Ref: 0541r02v01

**RE: 182—186 GERTRUDE STREET, NORTH GOSFORD
DEVELOPMENT APPLICATION FOR A RESIDENTIAL DEVELOPMENT (DA23/3021)
TRAFFIC LETTER OF RESPONSE TO COUNCIL REQUEST FOR INFORMATION**

PLANS
GROUND FLOOR PLAN

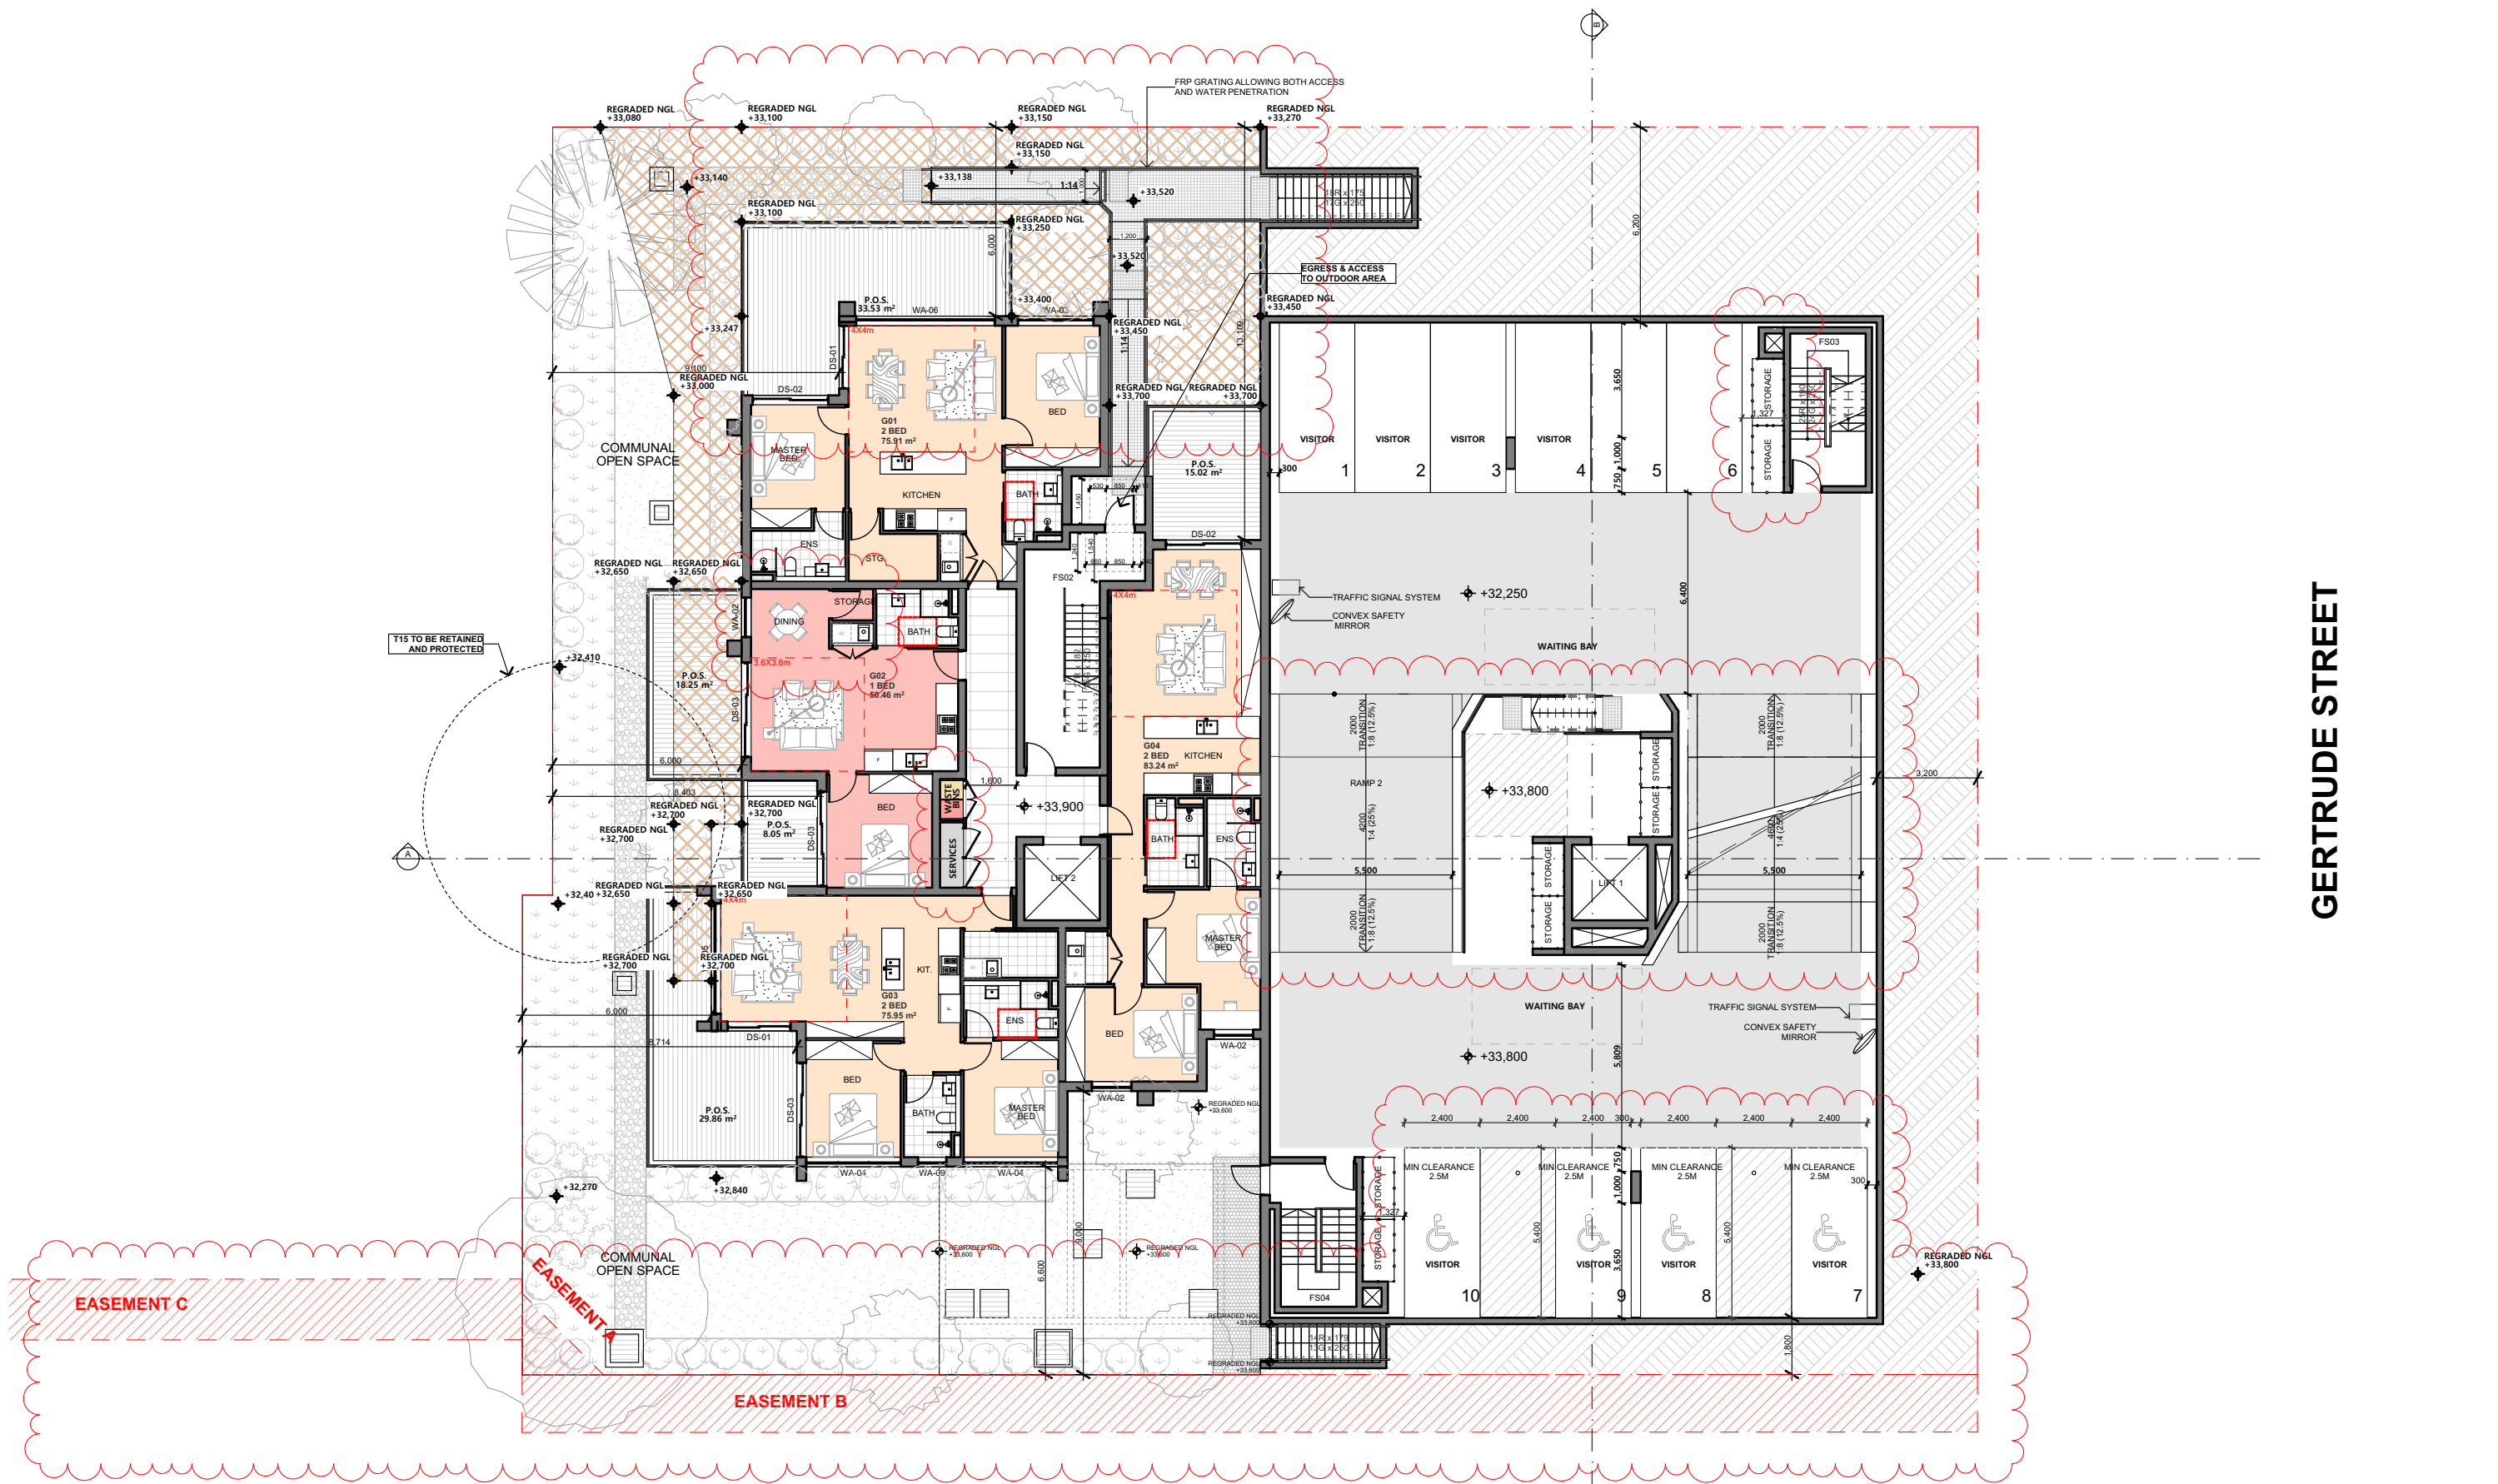
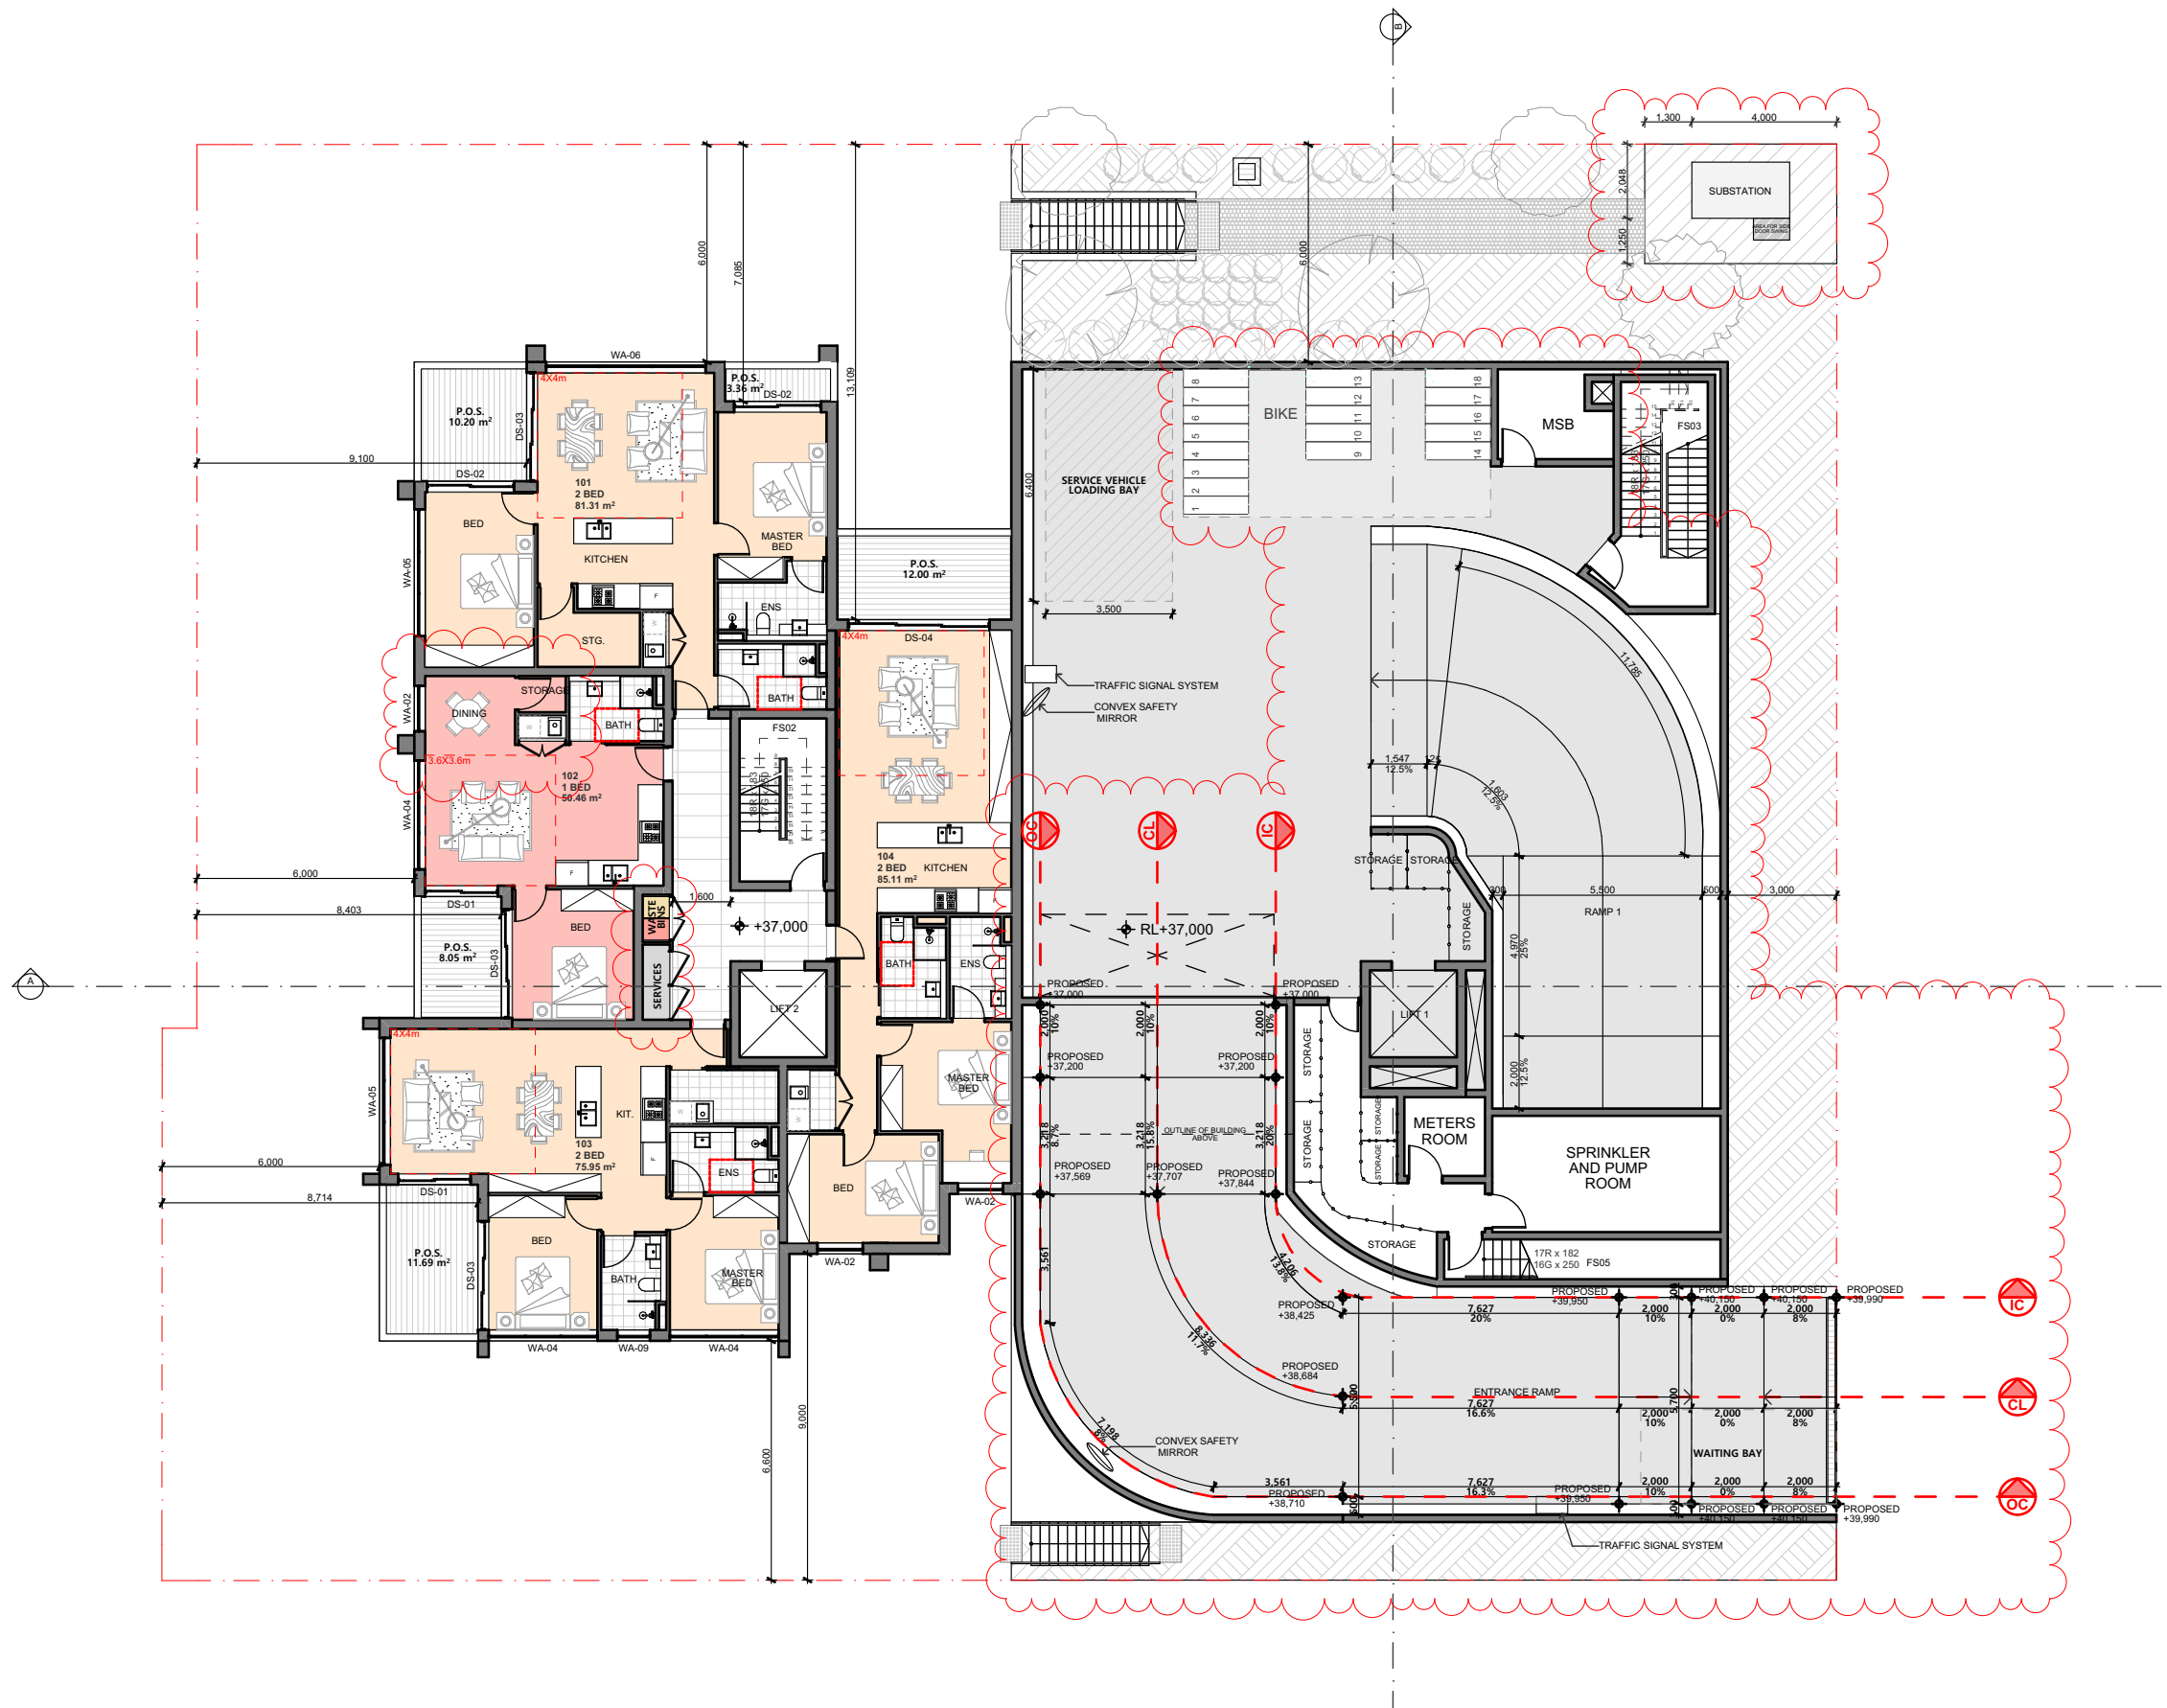
Requests to widen circulatory ramps to improve vehicle manoeuvrability

Nevertheless, further widening of the curved ramps between Level 02 and Level 01 and Level 01 and Ground Floor has been undertaken on amended architectural plans provided as **Attachment 1**, which further improves the ability for two vehicles to pass one another.

All ramps between the Ground Floor and Basement Levels have been widened to 5.5 metres between kerbs, as requested (**Attachment 1**). Traffic signals are maintained to further manage infrequent two-way vehicular conflicts.

DRAWING TITLE :
**DETAILS
ROLLOUT-RAMP SECTION**

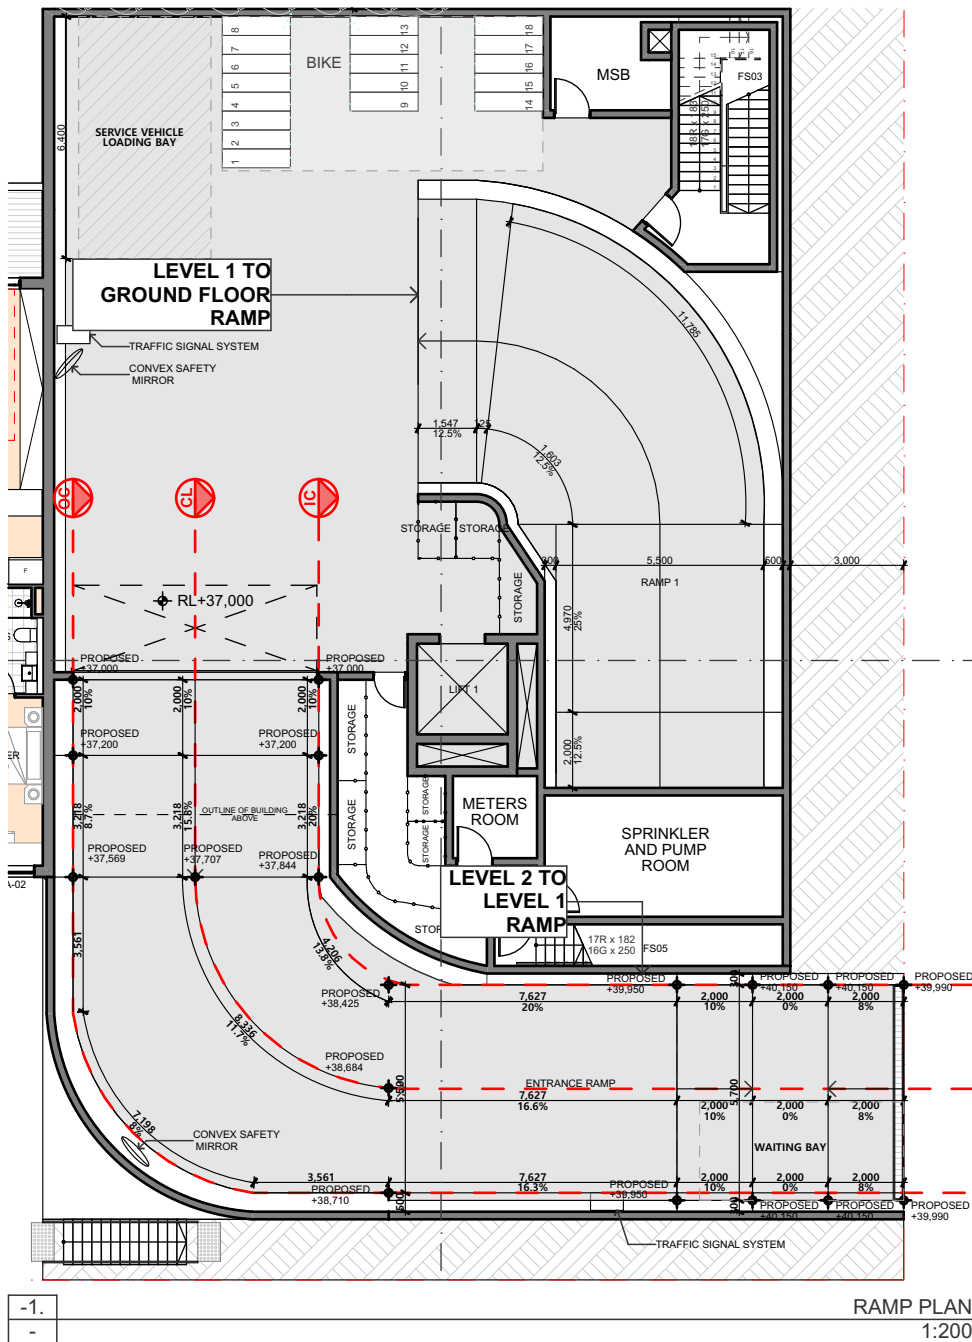
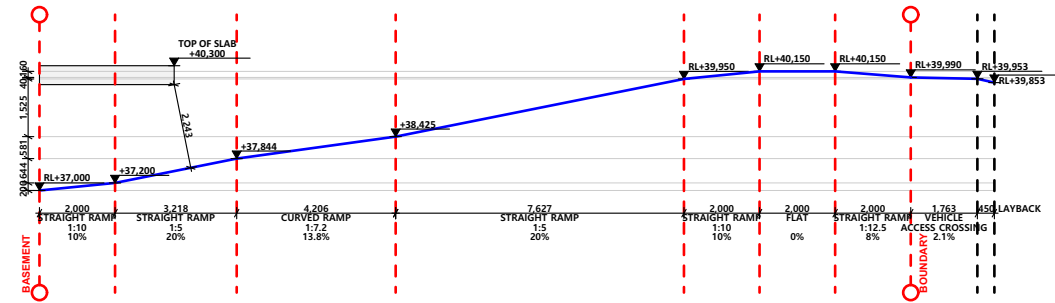
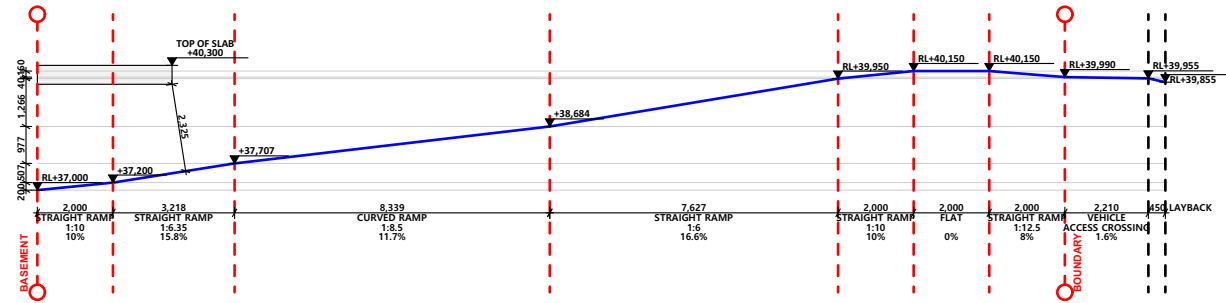
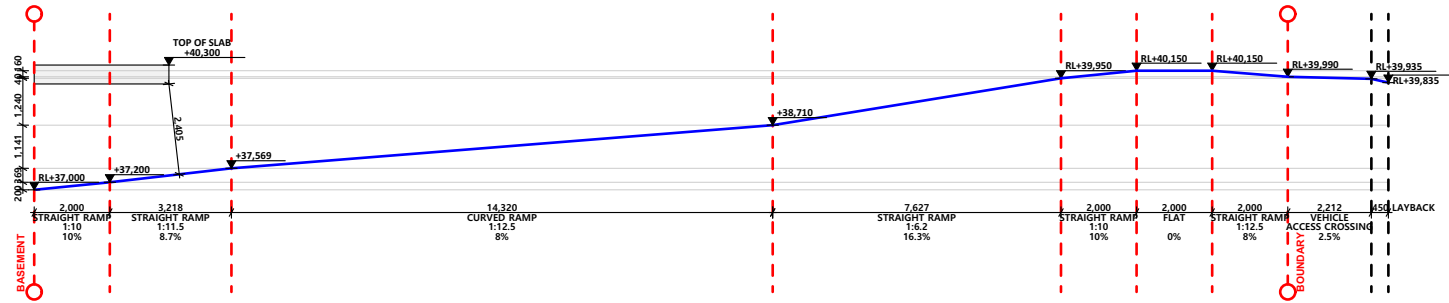
Lack of detail over the proposed vehicle ramp and long sections

Long sections of the vehicle ramp between Gertrude Street at Level 02 and Level 01 have been prepared along the inner and outer kerb edges, plus the ramp centreline, and are provided in **Attachment 1**.
